Subject: Submission of Non-Compliance Information Report  
Safety (Non-Compliance) Recall B0N (B1N) – **Preliminary Notice (Dealership In-Stock Vehicles)**  
2011 and Certain early 2012 Model Year Sienna Vehicles  
Tire and Loading Information Placard

**TECHNICAL INSTRUCTIONS**  
**FOR**  
**DEALERSHIP IN-STOCK VEHICLES\***  
**NON-COMPLIANCE CAMPAIGN B0N**  
**TIRE AND LOADING INFORMATION PLACARD (LABEL)**  
**2011 – CERTAIN 2012 MODEL YEAR SIENNA**

## C. CONFIRMATION AND APPLICATION OF THE NEW TIRE AND LOADING INFORMATION PLACARD (LABEL)

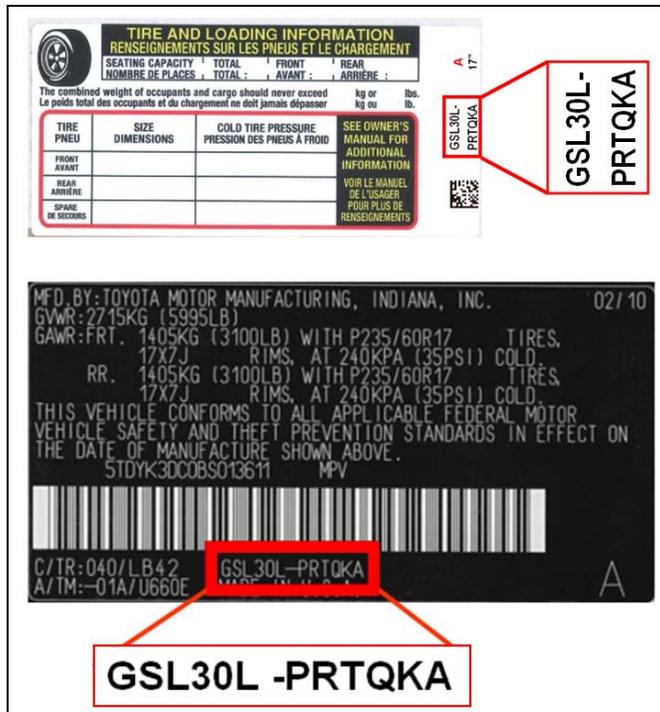
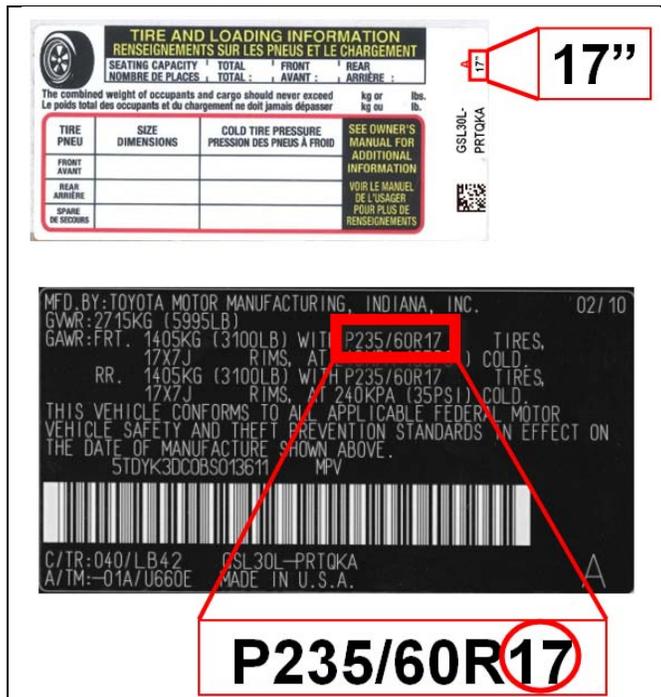
1. VERIFY THE KATASHIKI CODE ON THE NEW TIRE AND LOADING INFORMATION PLACARD (LABEL) MATCHES THE CERTIFICATION LABEL ON THE VEHICLE

2. VERIFY THE RIM SIZE NOTED ON THE NEW TIRE AND LOADING INFORMATION PLACARD (LABEL) MATCHES THE RIM SIZE ON THE CERTIFICATION LABEL

**IMPORTANT NOTE:** Some Tire and Loading Information placards (labels) have the same **Katashiki** but different rim size designations. The **Katashiki** **AND** Rim Size must be matched before application of the new label.

3. APPLY THE NEW TIRE AND LOADING INFORMATION PLACARD (LABEL) OVER THE OLD LABEL

- a) Clean the original label with a clean dry cloth.
- b) Apply the new label

**2. MODIFY THE TOP 2 ROWS OF THE OWNERS MANUAL OVERLAY UPDATE STICKER**

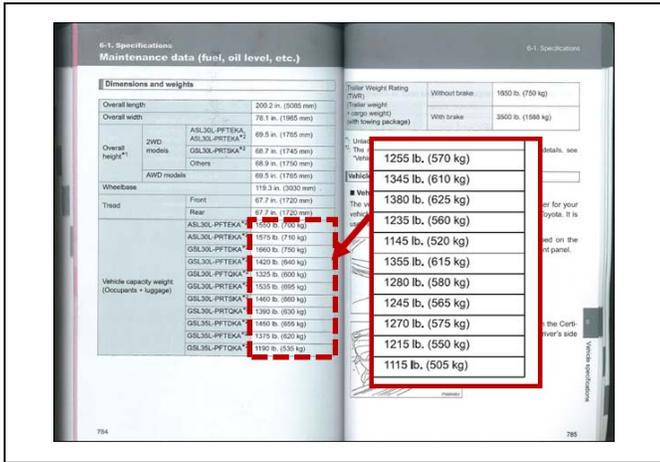
- a) Cut off the top 2 rows of the owner’s manual overlay update sticker for gU-1 owner’s manuals.

### 3. APPLICATION OF THE NEW LOAD CARRYING CAPACITY ADDENDUM LABEL

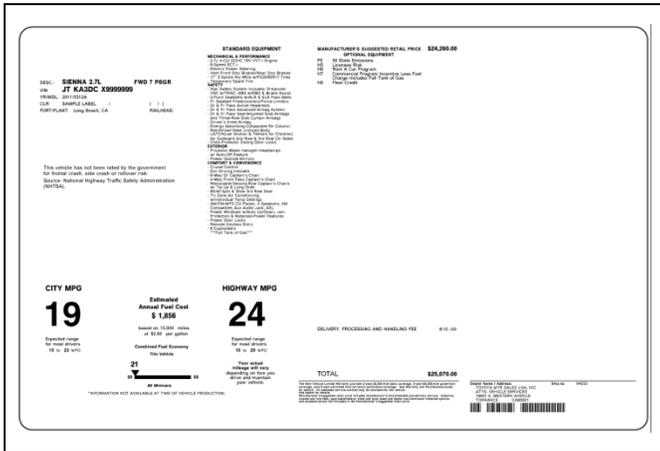
- a) Subtract the weight of the removed component(s) from the previous Load Carrying Capacity Addendum Label value. Using a permanent marker write the revised calculated value on the new Load Carrying Capacity Addendum Label.

**NOTE: Only subtract the weight of accessories removed from the vehicle.**

- a) Clean the existing Load Carrying Capacity Addendum Label using a dry cloth
- b) Apply the new Load Carrying Capacity Addendum Label over the existing label
